RE: OSDS Plan 6820 Koandah Gardens (McDaniel Prop. "Lot 9")

Mound/OSDS Revision Comments

RE: **McDaniel Property, proposed Lot 9 and Non-buildable Preservation Parcel 'C',
Percolation Certification Plan; comments**

1 SHEET OF 2

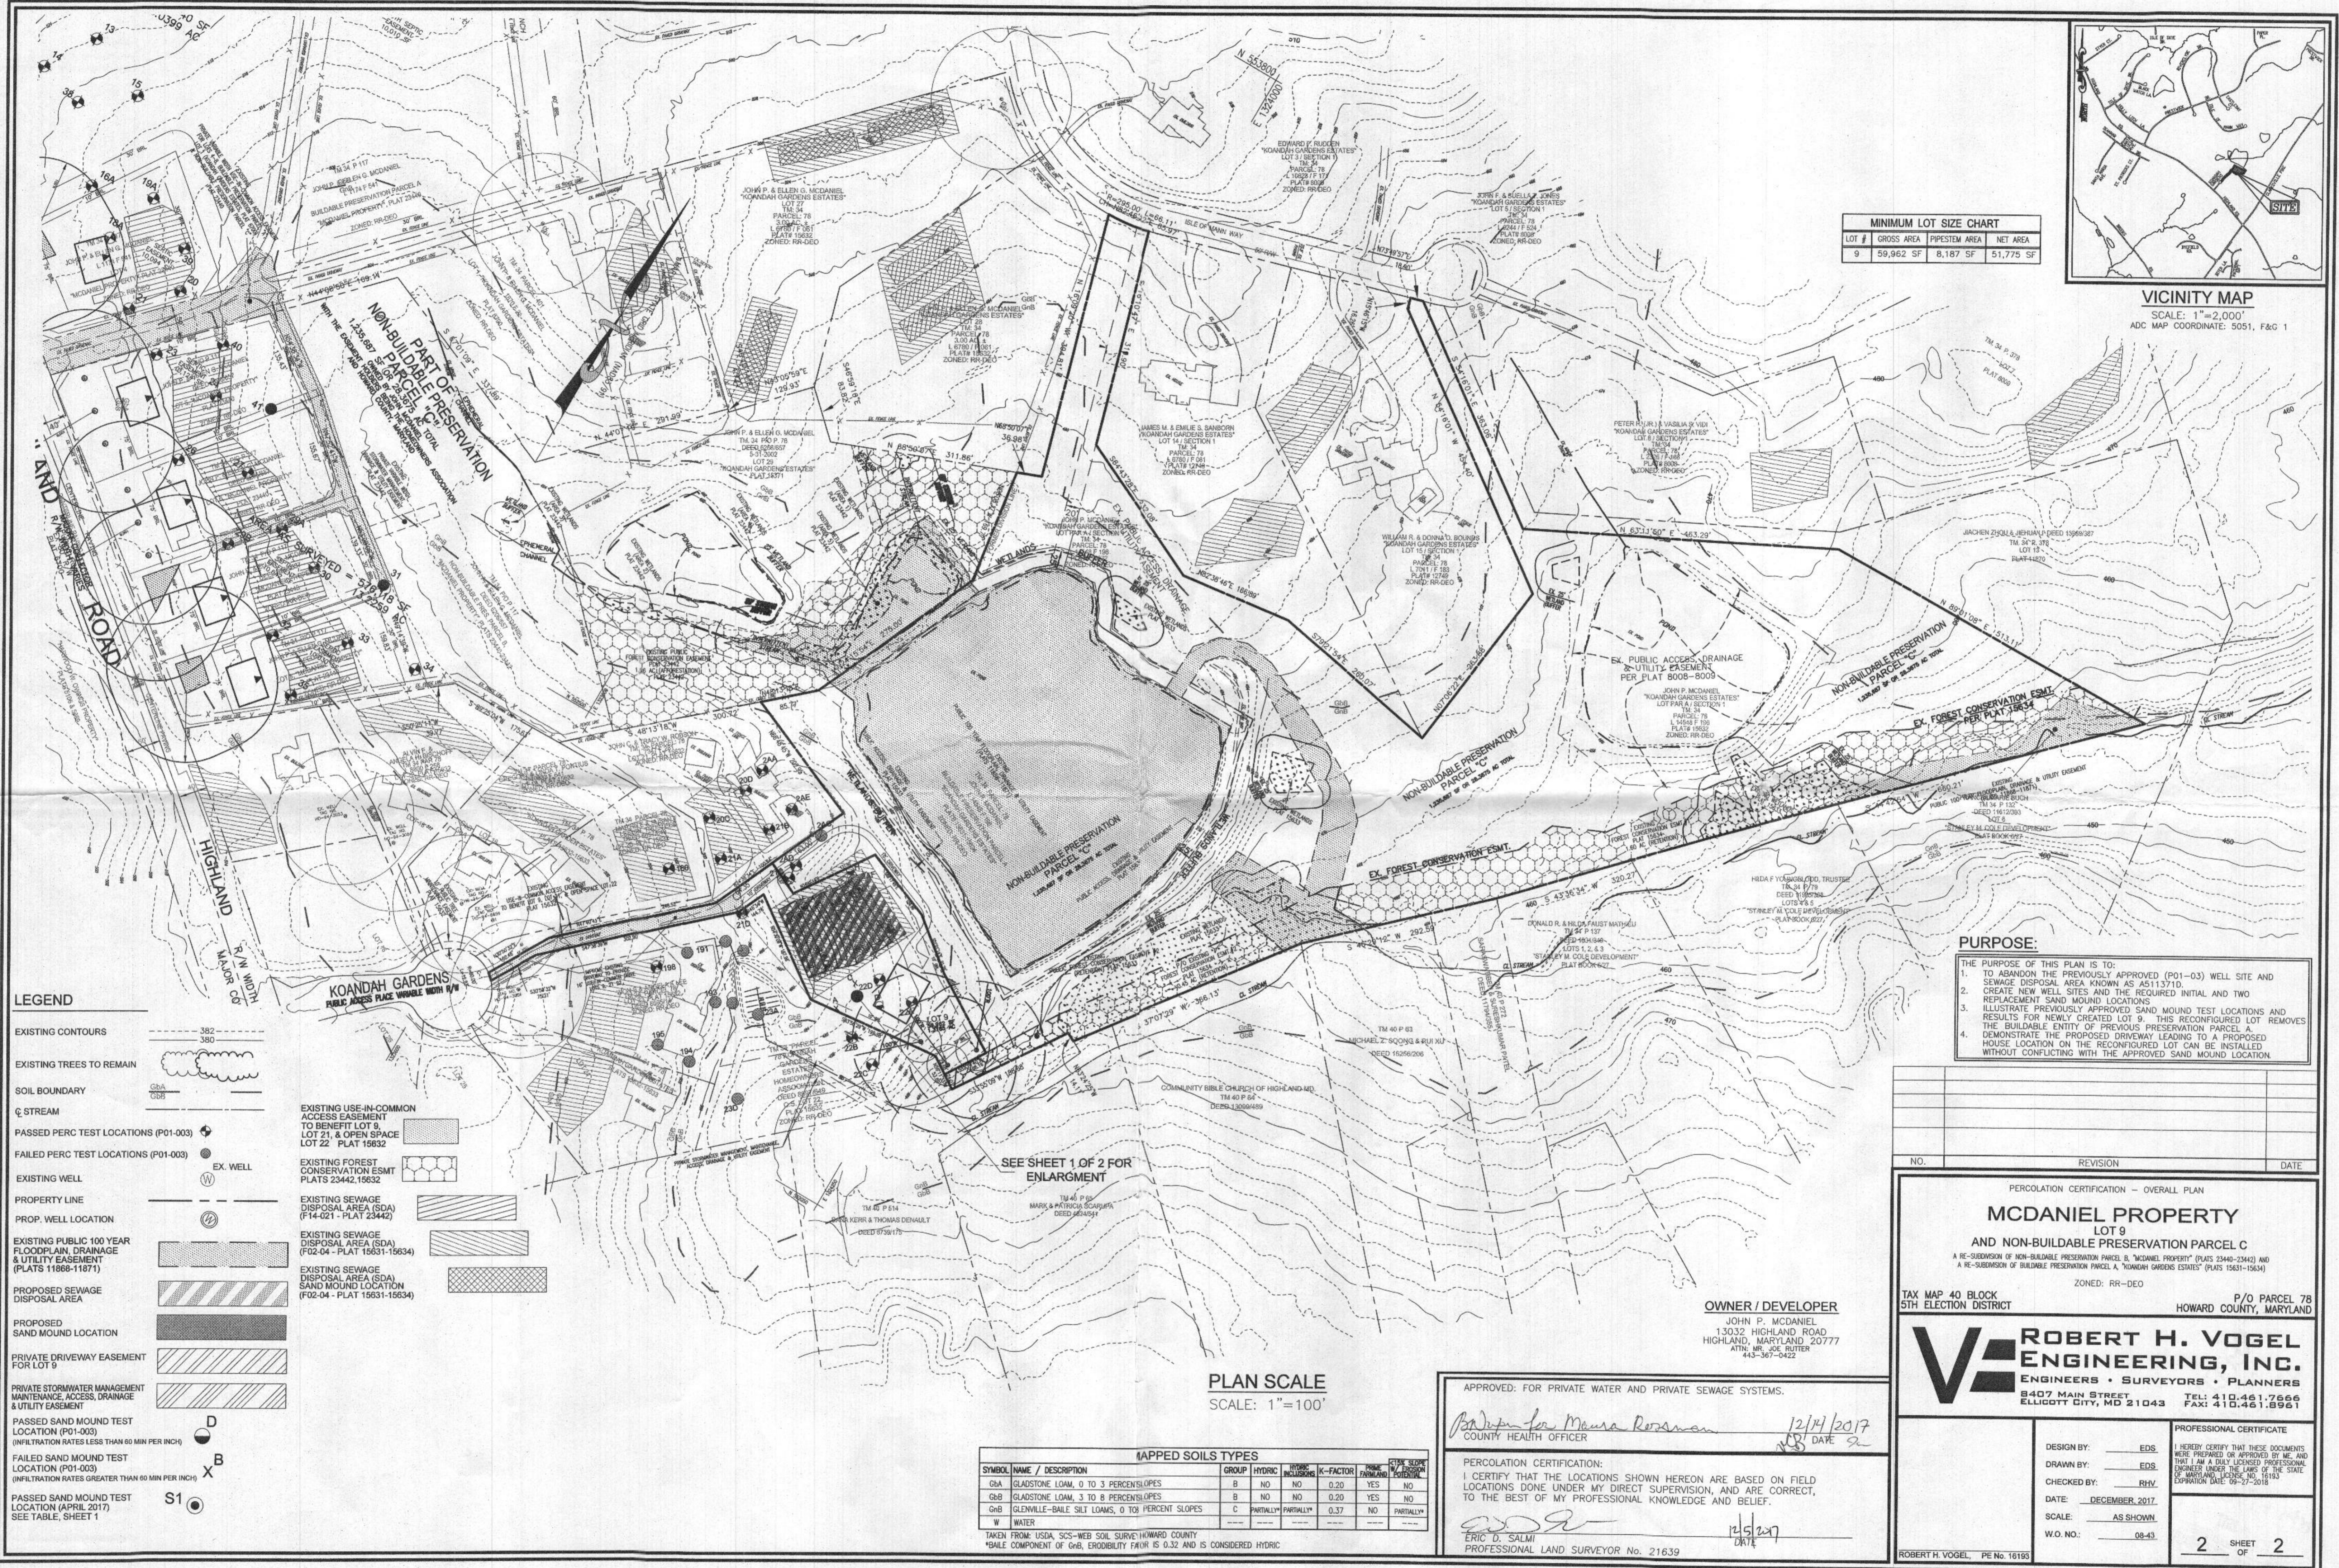
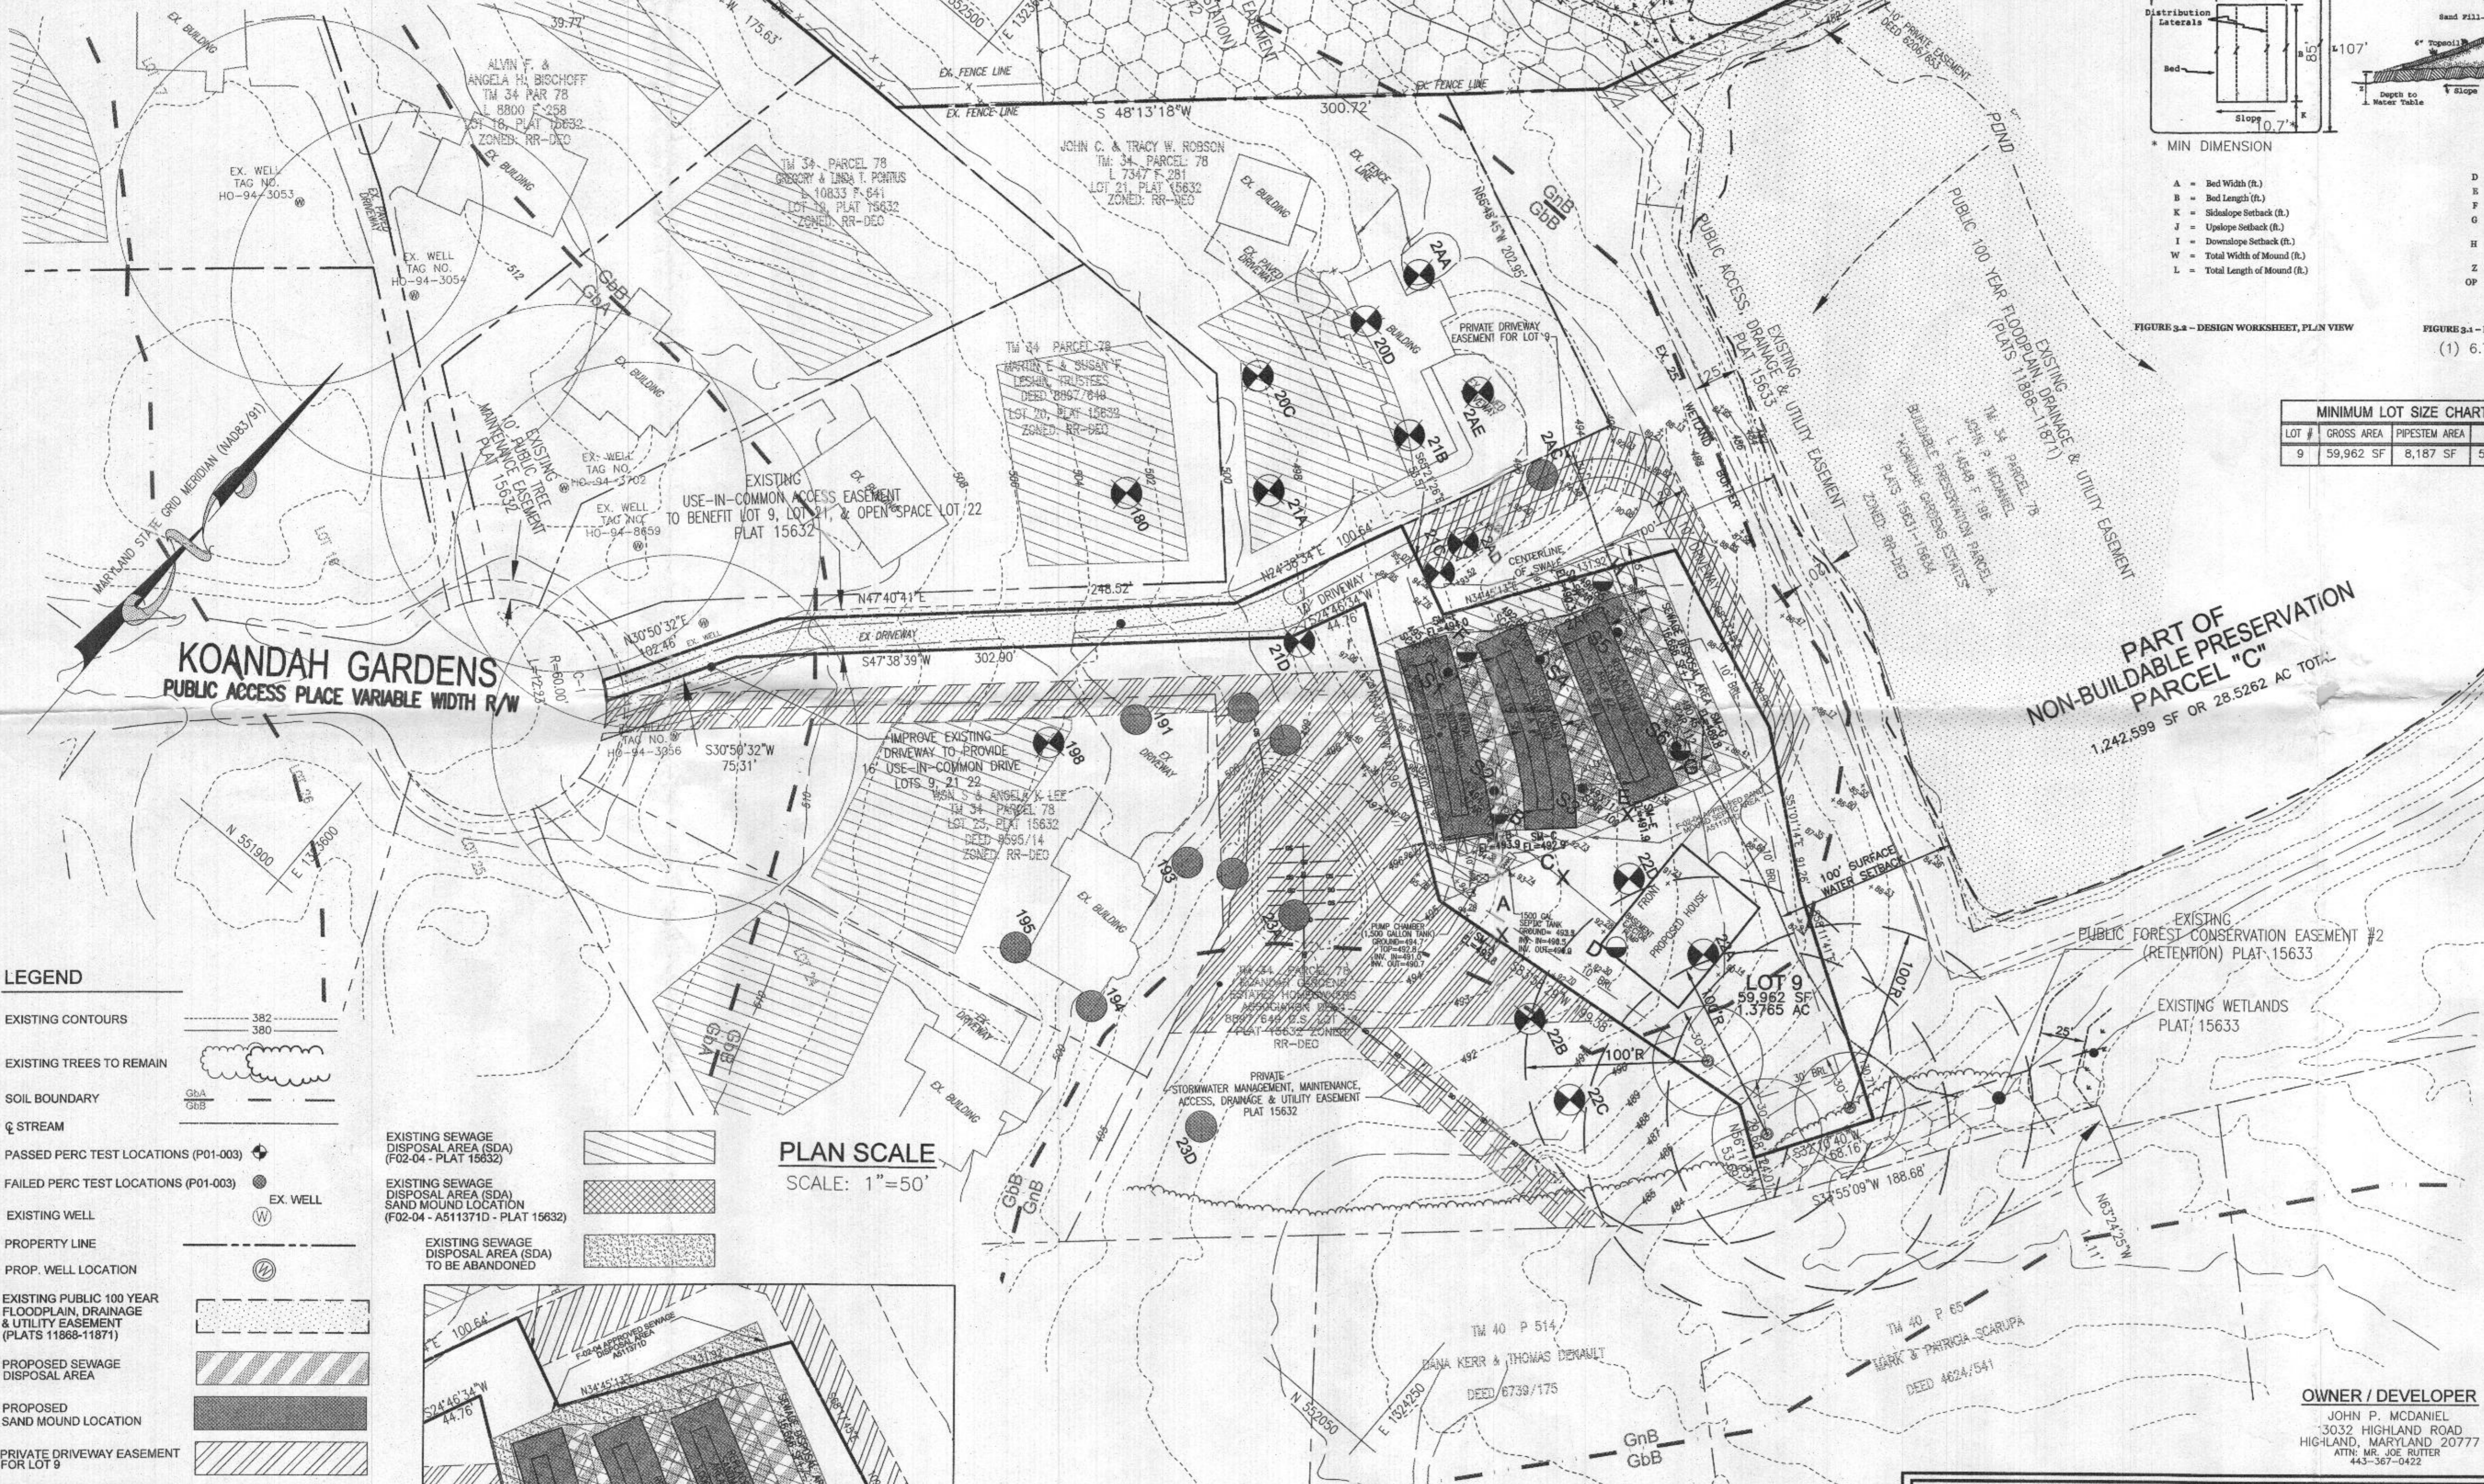
1. On SHEET 1, illustrate the previously approved configuration (Plat 15632) of the sewage disposal area (SDA) proposed for proposed Lot 9.
 - a. Using a different symbol, illustrate and label area (sq.ft.) that is being abandoned.

- b. Using another different symbol, illustrate and label area (sq.ft.) that is being added.
2. In the plan view, label the SEWAGE DISPOSAL AREA as such (not Septic Easement).

3. In LEGEND for SHEET 1,
 - a. the direction of the crosshatching in the symbol for PROPOSED SEWAGE DISPOSAL AREA doesn't match the direction in the plan view.

- b. The 100-year flood plain symbol is not observed in the plan view
 - i. Change the symbol in the plan view or in the LEGEND, OR
 - ii. Delete the symbol from the LEGEND.

4. On SHEET 1, I do not see that a stream centerline is illustrated.
 - a. Illustrate the stream centerline as it occurs, OR
 - b. Delete the symbol from LEGEND.

1. Comment complied with. Previously approved SDA configuration of P-01-003 and F02-04 for previous Plat 15632 - Buildable Preservation Parcel A (new Lot 9) has been added to plan.

1.a. For clarity, a detail has been added to the plan to address this comment; i.e. area to be abandoned.

3.a. The hatching pattern for Proposed Sewage Disposal Area has been amended. In addition, the hatch pattern direction has been amended to exactly match that in plan view.

4. An existing Intermittent Stream feeds the pond to the east of Lot 9 from the northwest (Top of Plan View). Legend symbol amended to match plan view.
